**Planning Commission
Regular Meeting Agenda
Wednesday, November 16, 2022 at 7:00 p.m.**

1. Land use application #2022-01, "Dollar General zone change application - Assessor's Map 19-01-11-33, Tax Lot 06502" – Discussion/ Possible action **(p. 3 of packet)**
 - a. The public hearing is now open at ___ (state time)
 - b. Staff report – Henry Hearley, City Planner
 - c. Public comment
 - d. The public hearing is now closed at ___ (state time)
 - e. Planning Commission decision on Land Use file #2022-01

3. Land use application #2022-06, "Site plan review for Dollar General retail store and townhome multi-family residential development - Assessor's Map 19-01-11-33, Tax Lot 06502" – Discussion/ Possible action **(p. 51 of packet)**
 - a. The public hearing is now open at ____ (state time)
 - b. Staff report – Henry Hearley, City Planner
 - c. Public comment
 - d. The public hearing is now closed at ____ (state time)
 - e. Planning Commission decision on Land Use file #2022-06

Staff Report
Dollar General Zone Change Application
LU 2022 01
November 9, 2022

Figure 5. Applicant proposed urban street improvements along frontage of North Moss Street.

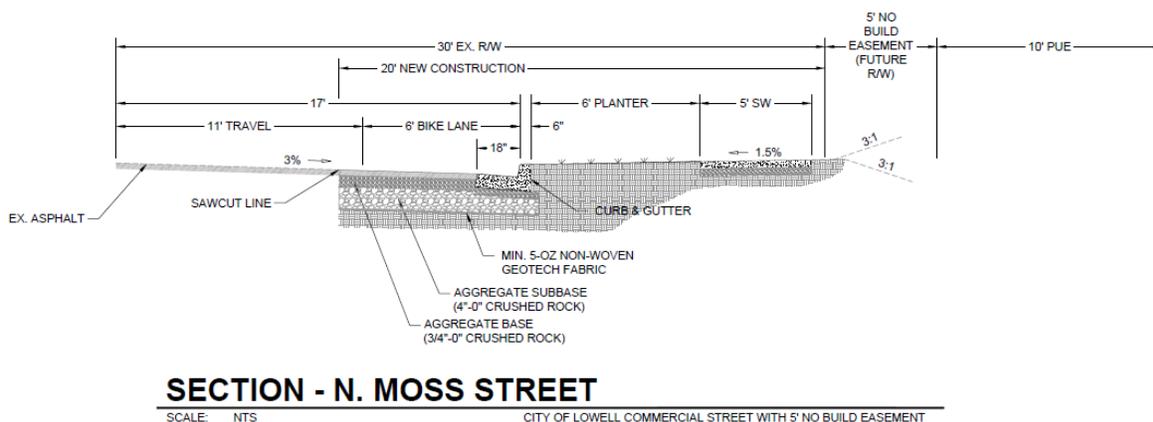
Staff Response: Urban street improvements including curbs, gutters and storm drainage are required for all property development in Lowell. Section 9.517 applies to the present proposal because the property fronts a portion North Moss Street. Because North Moss Street is a Lane County roadway facility, the street improvements must conform to the standards for Lane County roads. North Moss Street is classified as a Major Collector. As such, the applicant is proposing half-street improvements along the frontage of North Moss to include: 6' bike lane, 6' planting strip, 5' sidewalk, and the required 5' no-build easement. These improvements are consistent with Lane County standards. Criterion met.

Figure 5) to include 20' of total new construction, 6' bike lane, 6' planter strip, 5' sidewalk, 5' no build easement and 10' public utility easement. Final construction plans and details are subject to review and approval by Lane County as part of the Facility permit process. The City Public Works and Engineering departments reserve the right to review and comment on urban street improvements as part of the facility permit process.

Condition of Approval #5: Applicant shall construct urban street improvements consistent with Lane County Major Collector standards and as specifically proposed by the applicant (as seen in Figure 5) to include 20’ of total new construction, 6’ bike lane, 6’ planter strip, 5’ sidewalk, 5’ no build easement and 10’ public utility easement. Final construction plans and details are

Figure 6. Staff graphic showing setback issues.

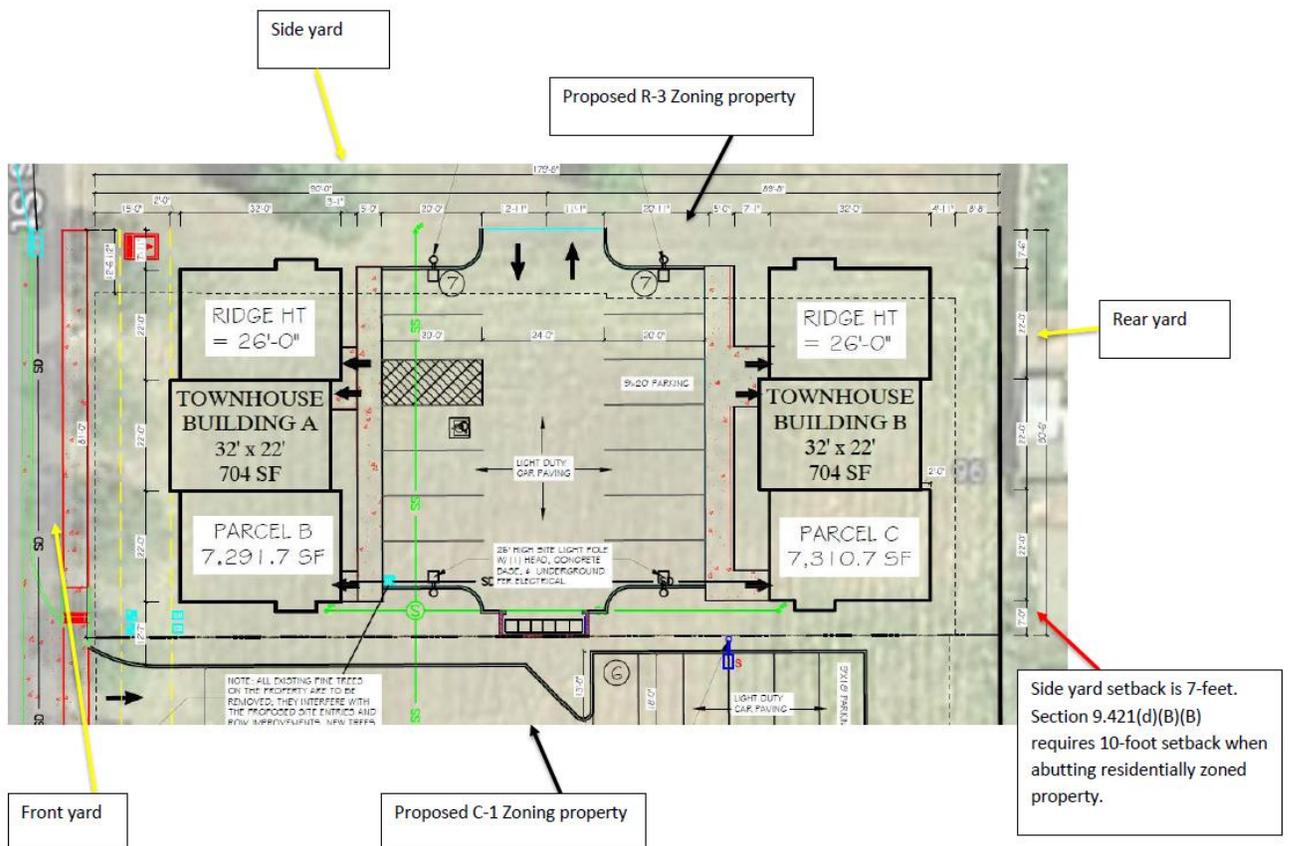
Staff Response: As seen in Figures 6 and 7, if the applicant is successful in rezoning the property, the site plan does not meet setbacks as stated in Section 9.421(d)(B)(B).

Staff Response: All setbacks are met, except for the side yard setback. The side yard setback is the setback that abut the proposed commercially zoned lot to the south. When a commercially zoned lot is adjacent to a residentially zoned property, the minimum setback required is 10-feet. As seen on Sheet A0.1, the setback is currently 7-feet. See Section 9.421(d)(2)(B). This criterion is not met.

Figure 7. Side yard setback issue between residential and commercial properties.

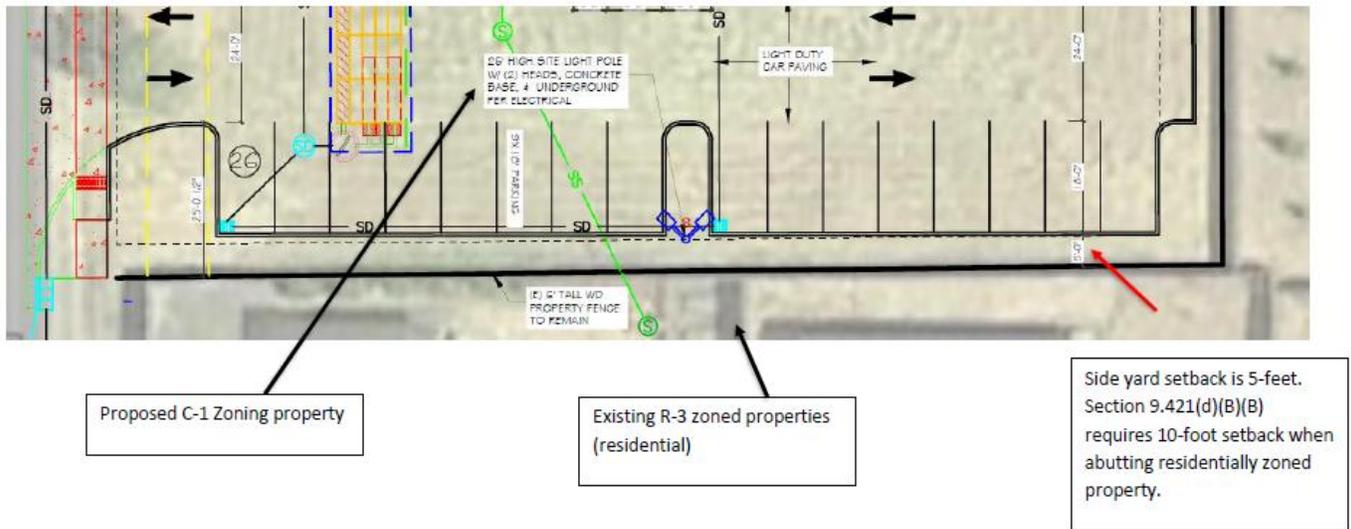
The side yard setback is 5 feet for single story buildings but 7.5 feet for two story structures. As seen on Sheet A0.1, the setback is 7-feet. However, the property located directly south of the townhomes is proposed to be zoned commercial. When a commercially zoned property is adjacent to a residentially zoned property, the side yard setback is increased 10 feet (see Section 9.421(d)(2)(B)). The side yard setback is not met.

**SITE PLAN
A0.1**

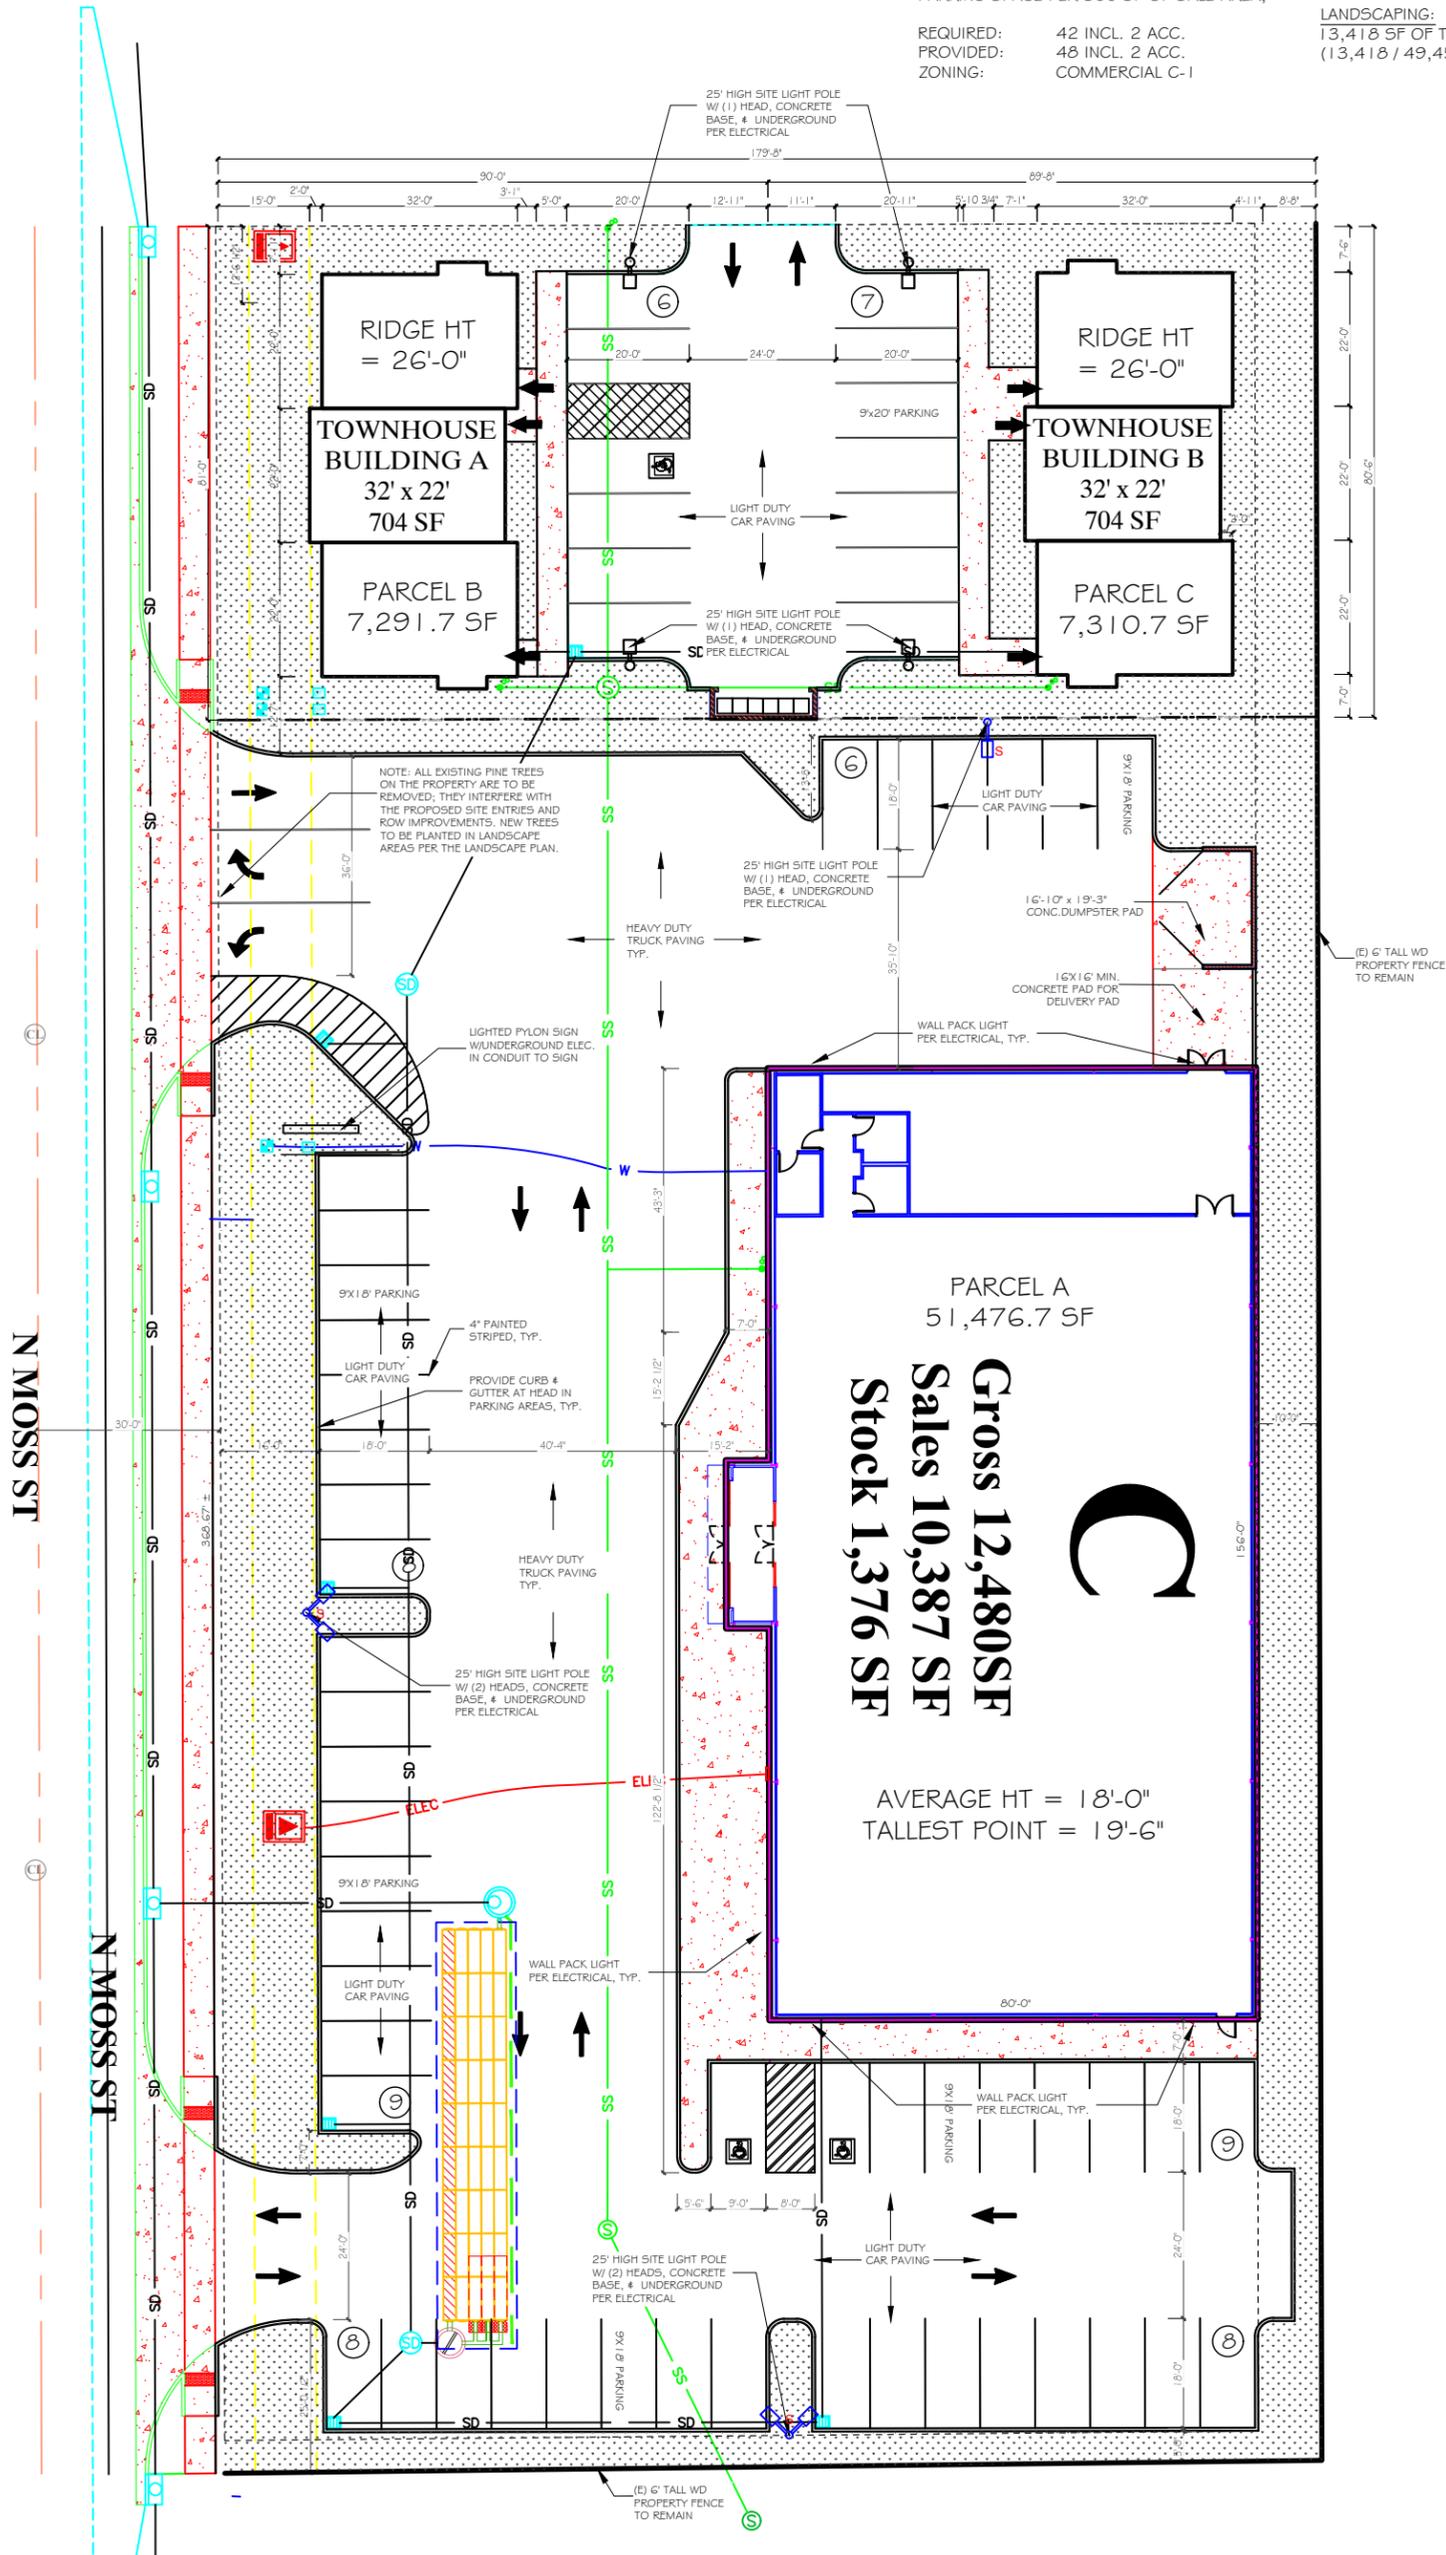
Staff Response: As seen on Sheet A0.1 the applicant is proposing a 16'-10" X 19'-3" concrete dumpster pad. The dumpster pad appears to be contained behind doors, but no details as to how the dumpster pad will be screened from public view and landscaped. The applicant is also proposing a 16'X16' concrete delivery pad. The delivery pad does not appear to be screened from public view or landscaped. Planning Commission must decide if the concrete deliver pad is a "service facility" and thus required to be screened from public view and landscaped. Staff request Planning Commission's decision on this issue. At a minimum, staff will require greater detail as to how the garbage collection area will be appropriately screened from public view and landscaped as required. This may be added as a condition of approval, but more information is required. The applicant should be prepared to address this issue at the public hearing.

AERIAL PLAN
A0.2

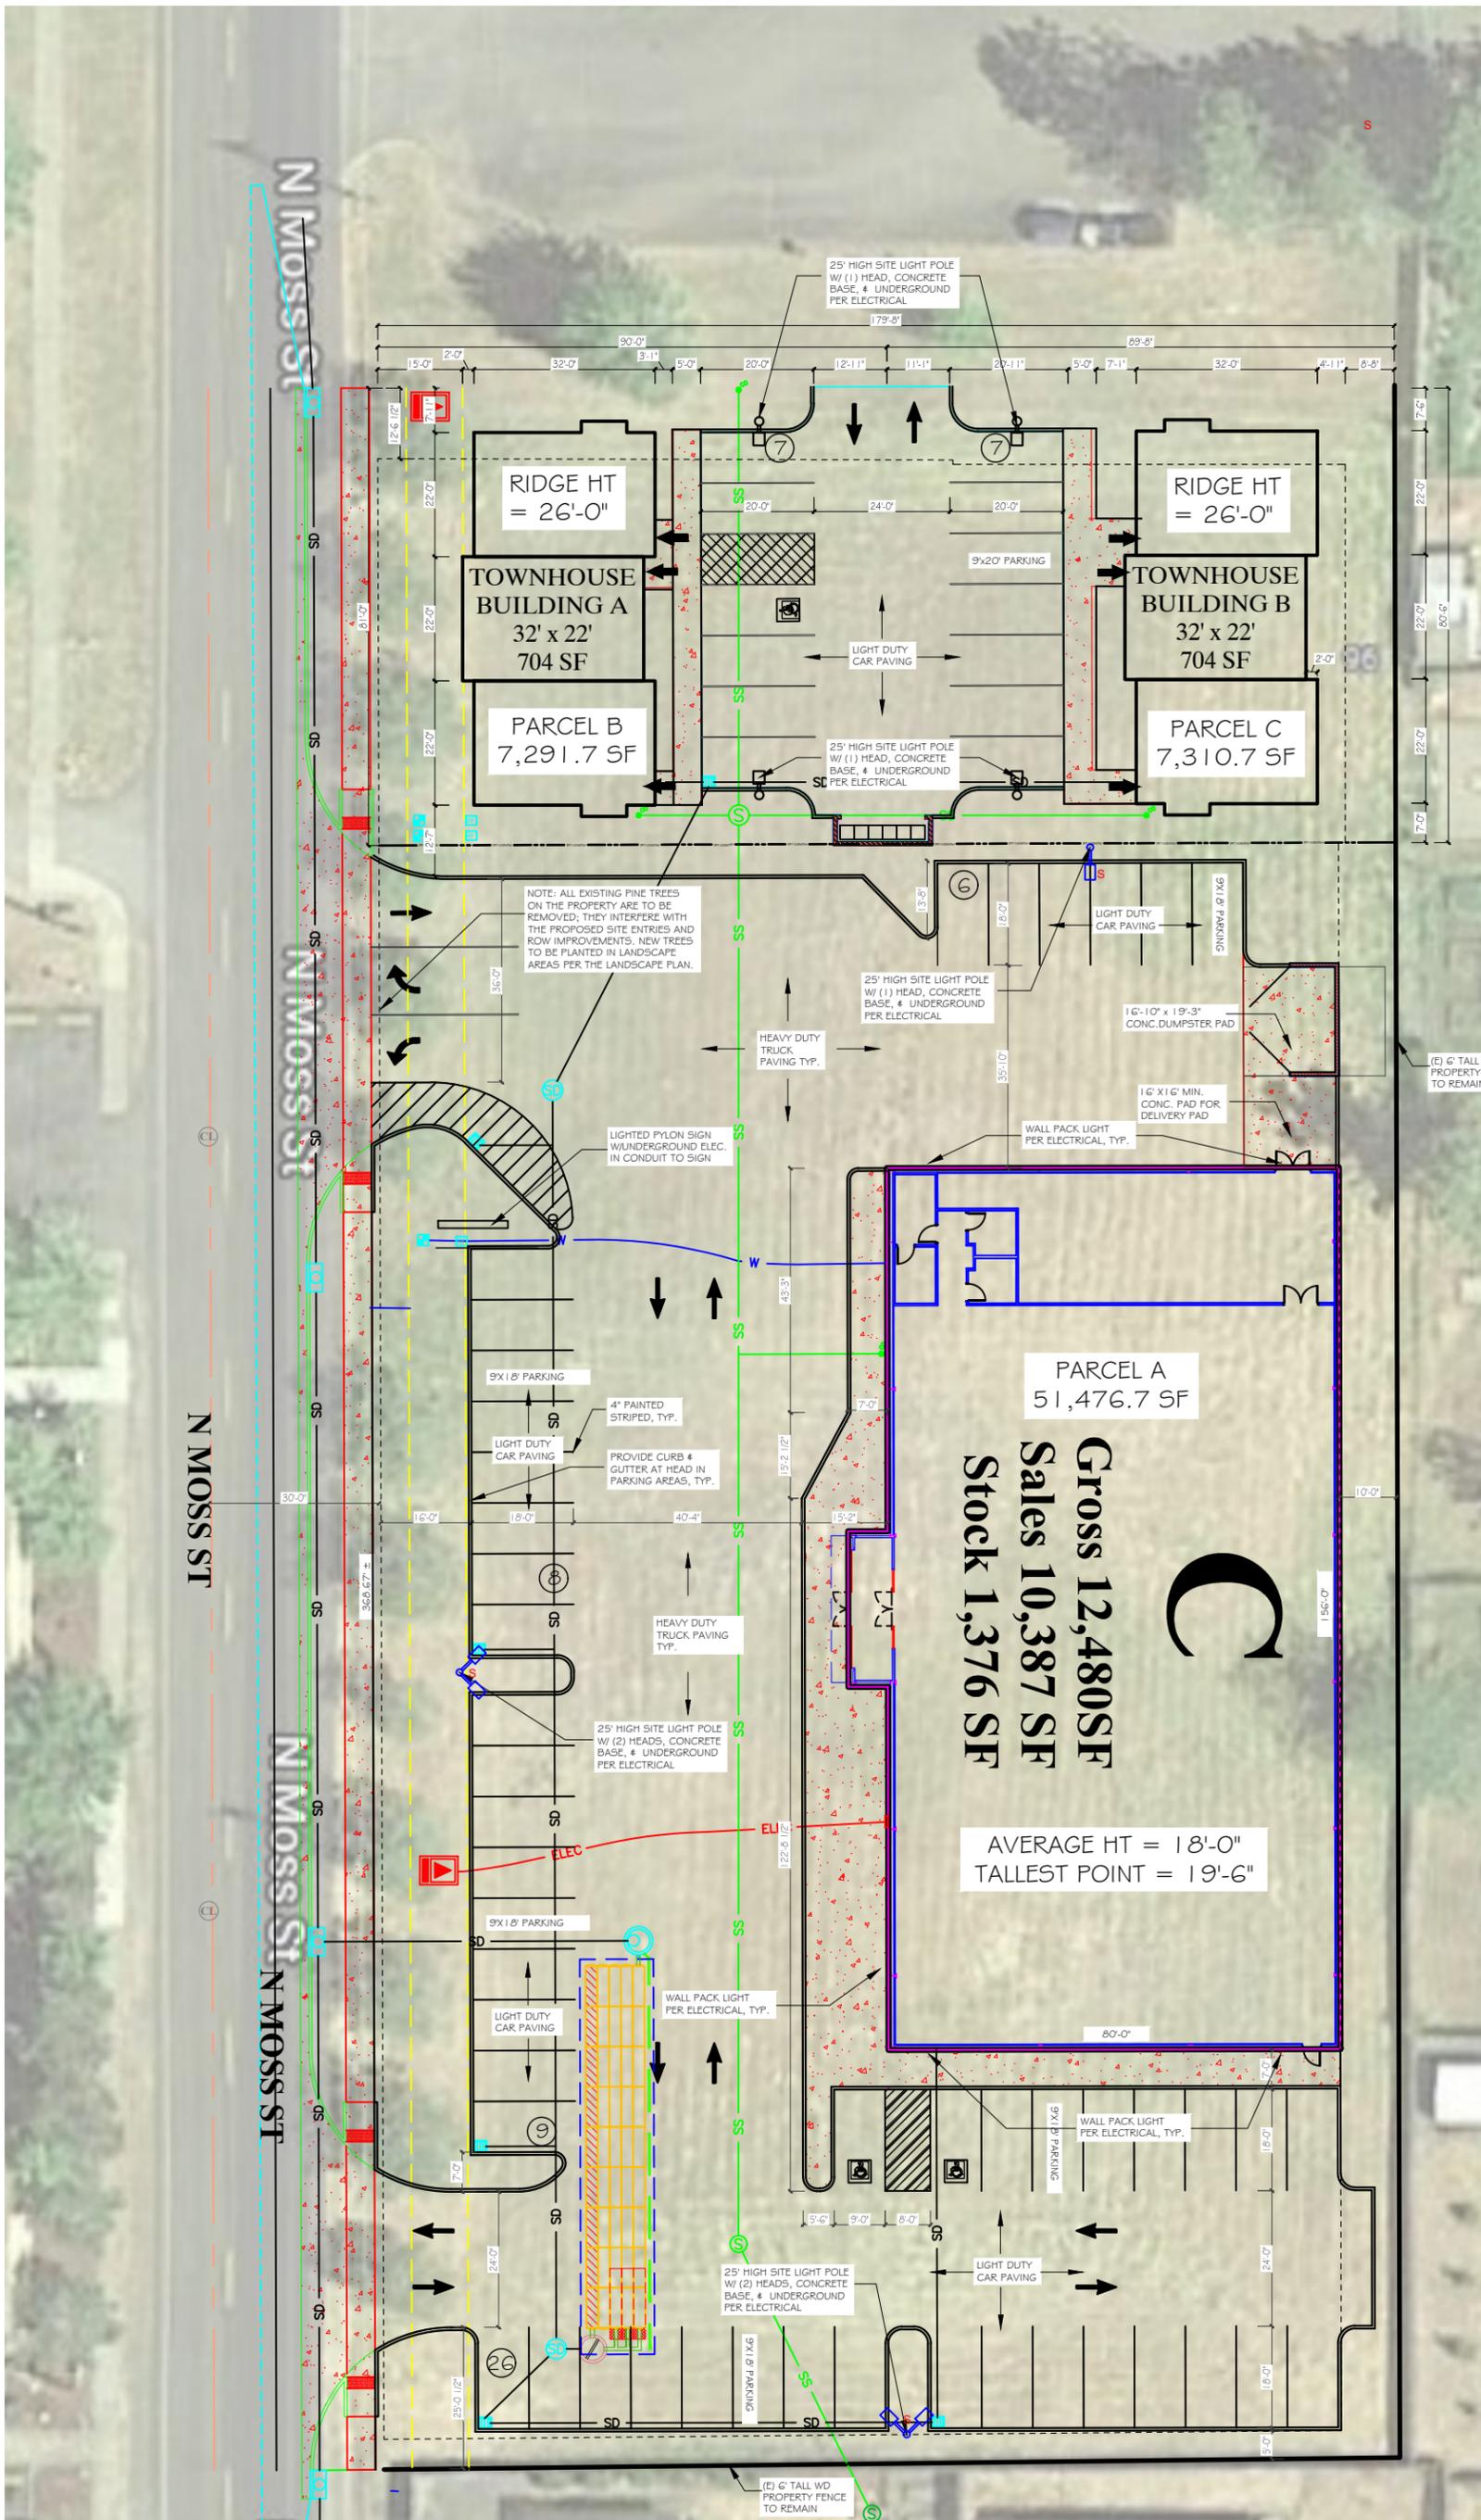
Furthermore, the portion of the property to be partitioned and rezone to R-3 will require a 10' side yard setback. As seen on Sheet A0.2, the applicant only shows a 7' setback. This will need to be revised to 10' or Planning Commission may cite this as a reason to deny the site plan.
